### **Agenda Item 3**

### **Deerpath Park**

**THE CITY OF LAKE FOREST  
BUILDING REVIEW BOARD APPLICATION**

**Consideration of a request for modifications to the amenity buildings (north and south pavilions) proposed to support the athletic fields.**

**SOUTH & EAST  
ELEVATIONS**

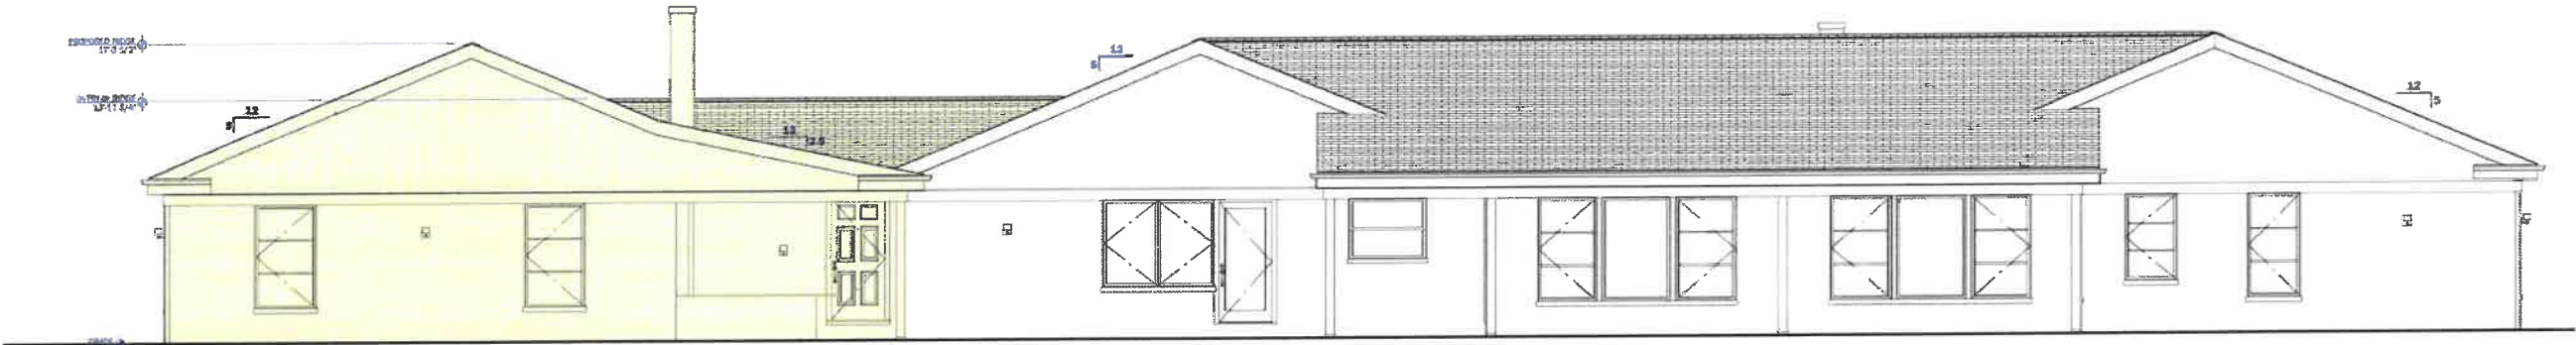
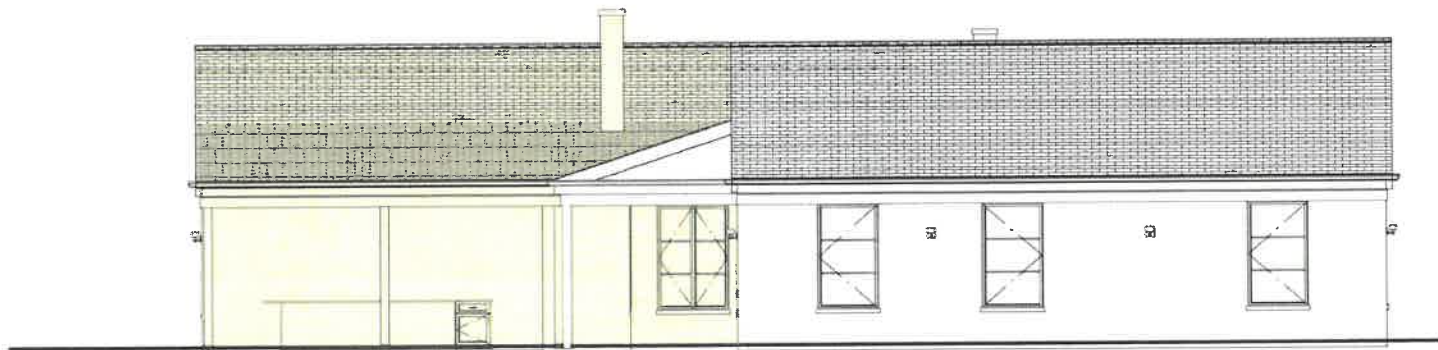
- Examples of contemporary style garage doors that the petitioner is considering are reflected on the revised plans. During the last meeting, concerns were raised by the Board about the large amount of glass and the commercial appearance of the garage doors.

3. Provide information on the location of the outdoor television, if proposed, and details on how off-site impacts will be mitigated.
4. Select garage doors with limited glass and a more residential appearance.

**Garage door widths and heights indicated clearly on the plans and elevations, and adjustments to the existing drawings have been made to ensure the accuracy of the existing construction and proposed addition. The brick previously shown above the garage door openings has been removed entirely as part of this dimensional revision.**

11) Explore a different style garage door and provide images of the proposed garage doors. **Three specific garage door options have been provided which include manufacturer, model, finish, and sample photos for reference.**

1 LANDSCAPE DEMOLITION PLAN  
SCALE: N.T.S.

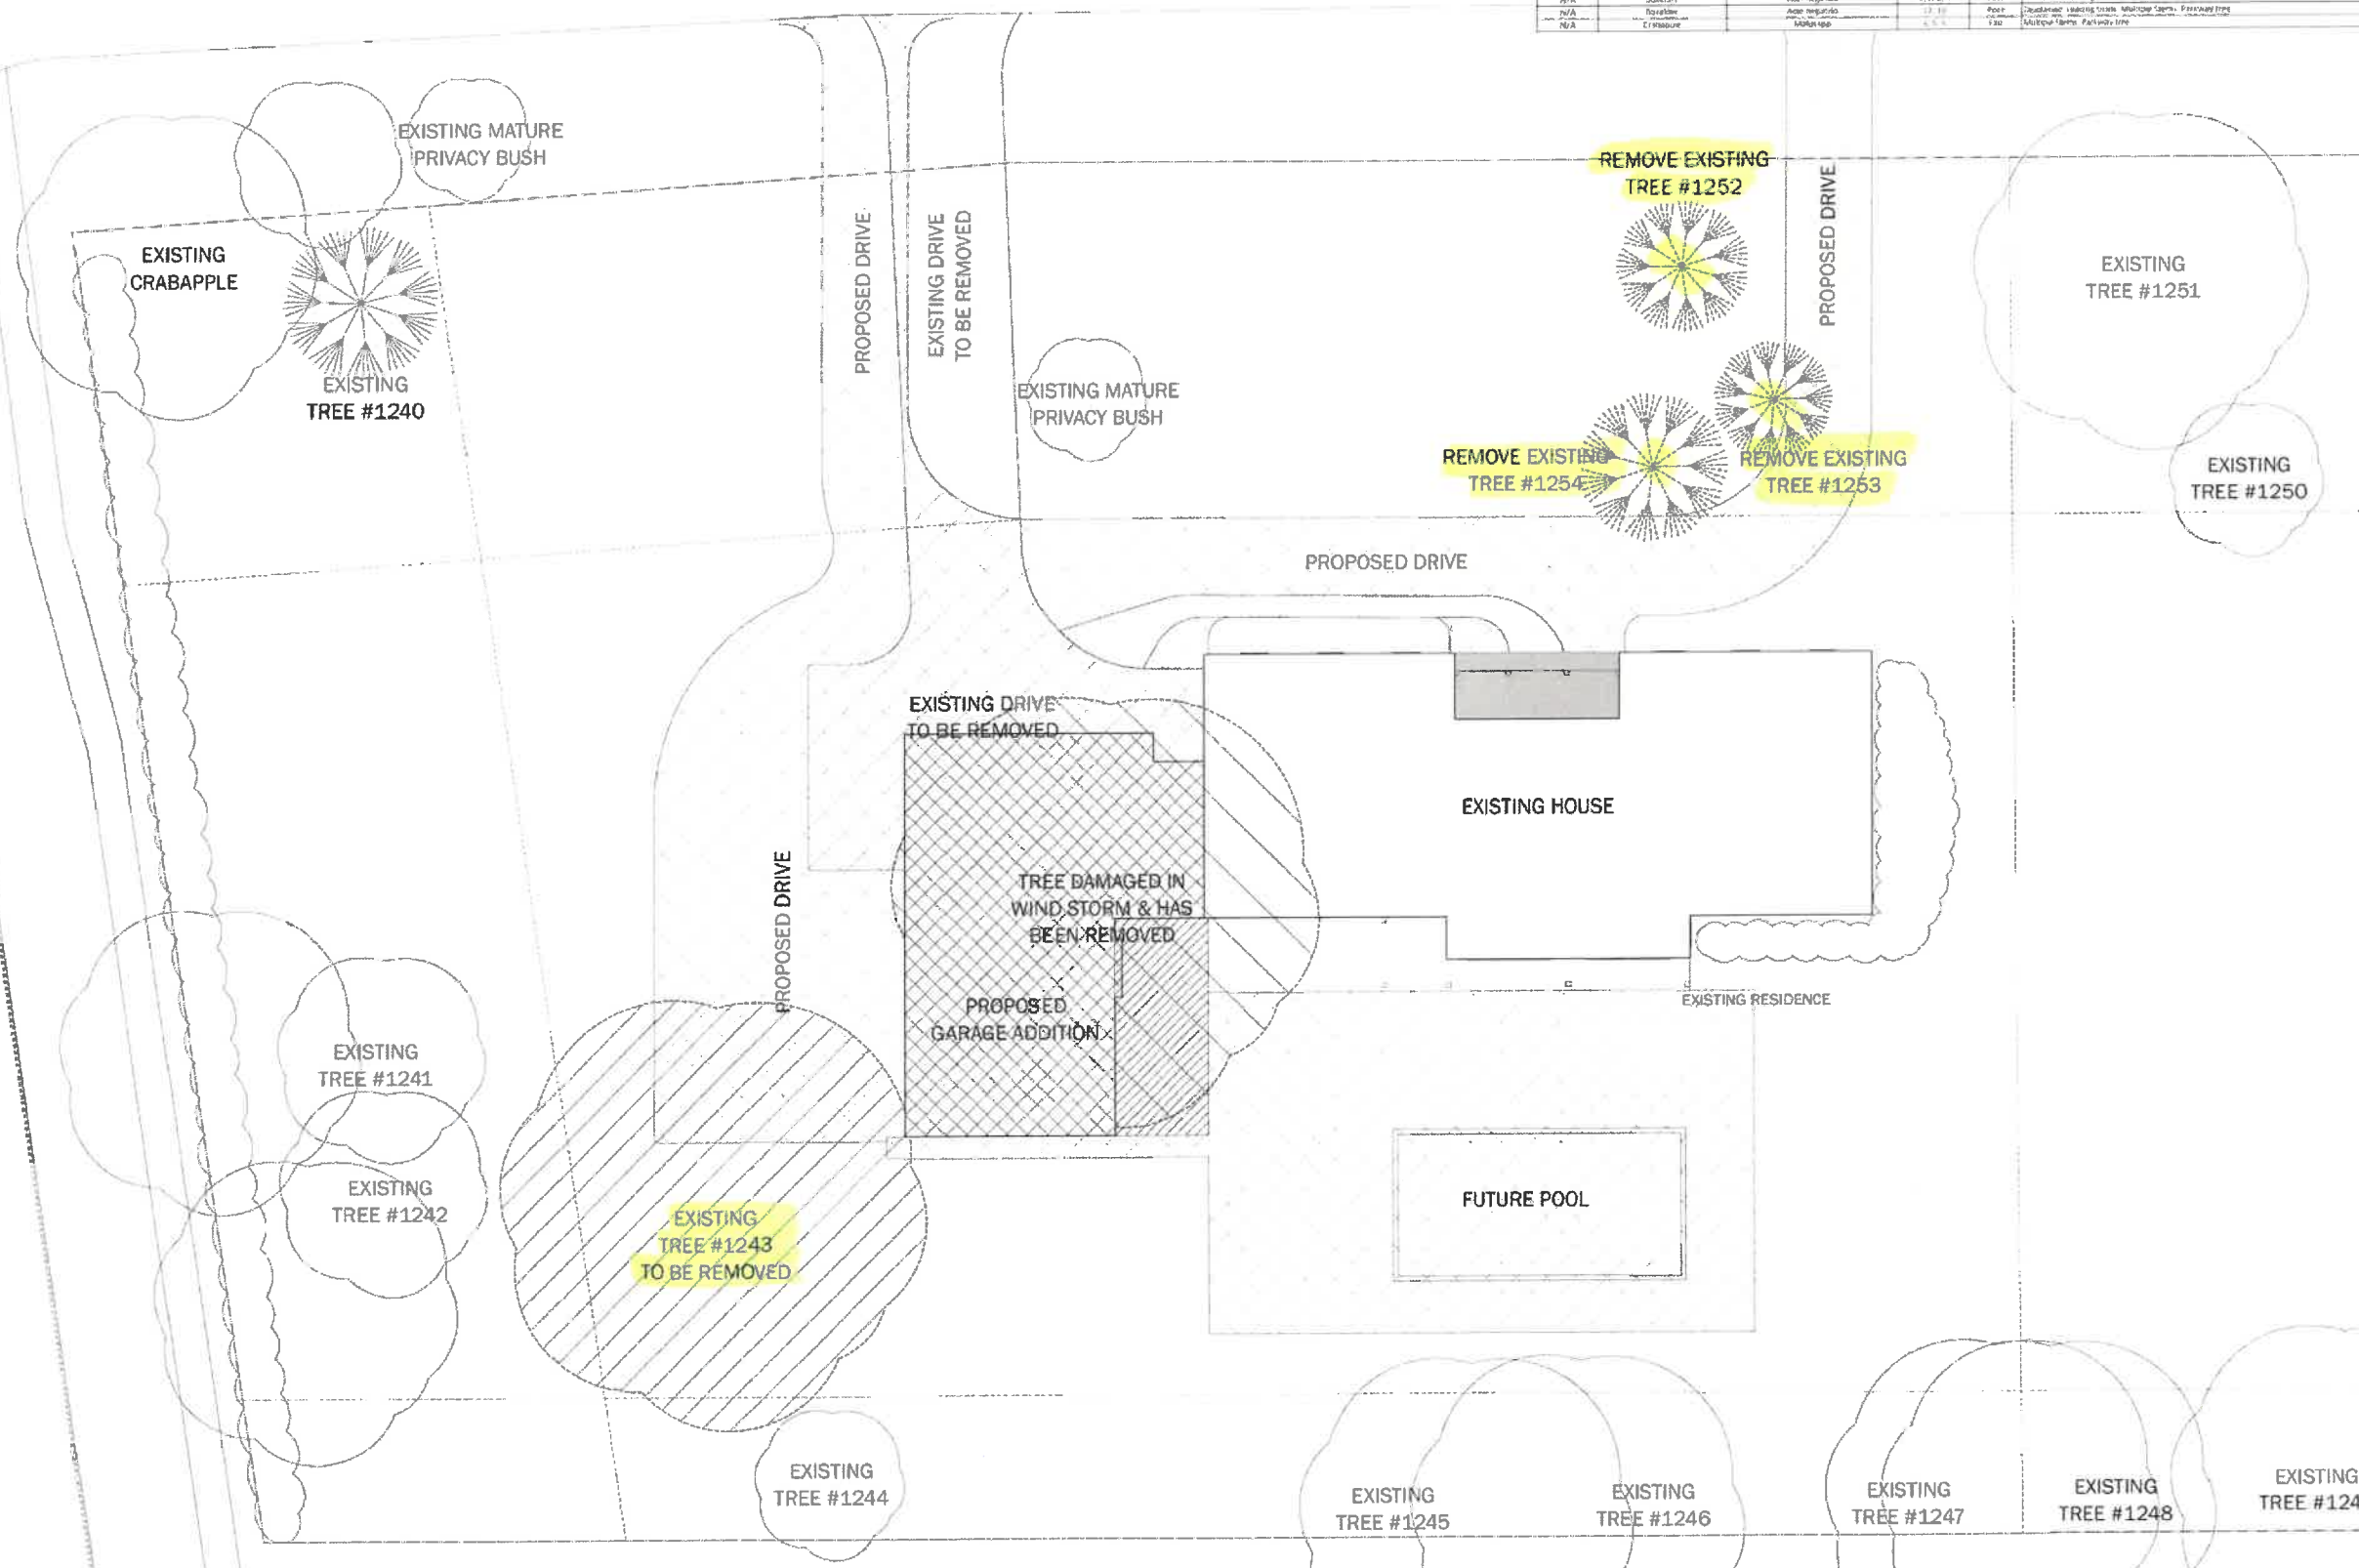
The tree removal plan submitted by the petitioner shows one Weeping Willow tree at the south end of the proposed driveway and three Spruce trees at the front of the home that will be removed. Based on the size, condition and species of the proposed for removal a total of 38 replacement inches will be required to be planted back on site.

Although not indicated on the tree removal plan, a Gingko tree on the west side of the existing driveway and two small Beech trees adjacent to the existing driveway entrance will be impacted by the proposed driveway and garage addition. The petitioner has indicated that the Gingko tree will be transplanted to another location on the site. Based on the information provided it is not clear whether the petitioner intends to also transplant the Beech trees. Any existing trees proposed for replanting on the site must be noted on the landscape plan so that the likelihood of survival can be evaluated by the City's Arborist and so that if transplanting is determined to be feasible, an appropriate adjustment for replacement inches can be made.

**The tree removal plan has been updated to further specify the existing trees and foliage on site to remain, and existing trees and foliage to be removed or relocated.**

## PRELIMINARY LANDSCAPE PLAN

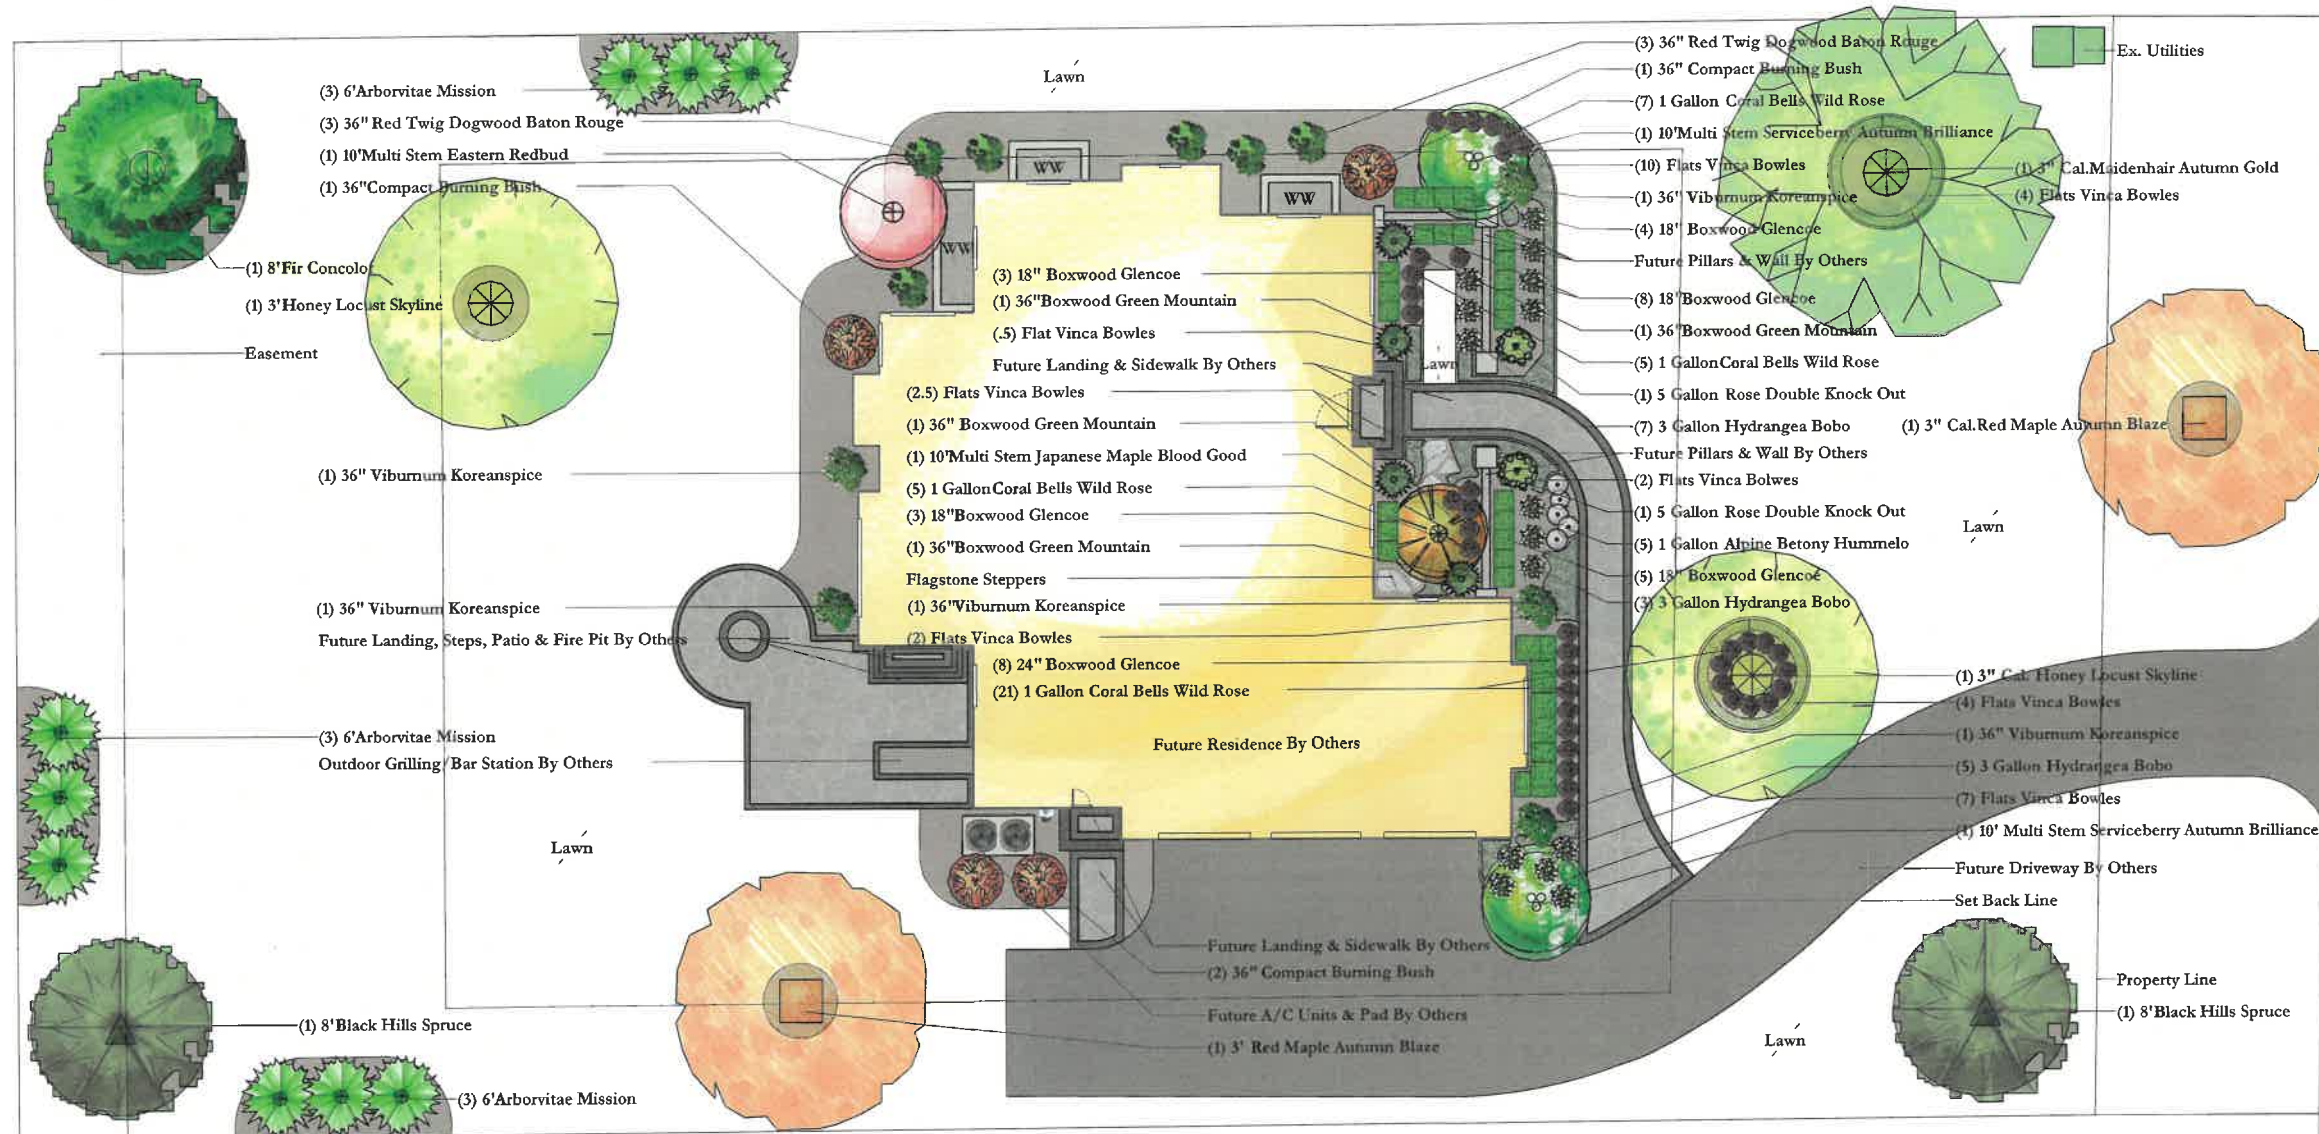
The petitioner submitted a conceptual landscape plan that reflects new arborvitae on the west side of the property and in the southeast corner of the site. Spruce and Bald Cypress trees are proposed in the southwest corner of the site and ornamental trees are proposed in the front yard. Shrubs are also proposed along the front and east sides of the home. Given the size of the proposed addition and impact to the streetscape and neighboring properties, additional landscaping will be necessary to soften the appearance of the addition from all viewpoints, including from the south and from the streetscape. As the construction of the

addition takes shape, some adjustments to the landscape plan may be necessary to effectively screen and soften the impact of the addition as proposed. In addition, given the removal of the large Spruce trees in the front yard, additional shade trees must be incorporated into the landscape plan to soften the appearance of the front façade of the home.

**Landscape plan has been revised and provides additional information on the proposed landscape to be added. Additional site photos of the existing site landscape have been provided in order to better assist in accurately showing the existing screening in addition to what is being proposed.**
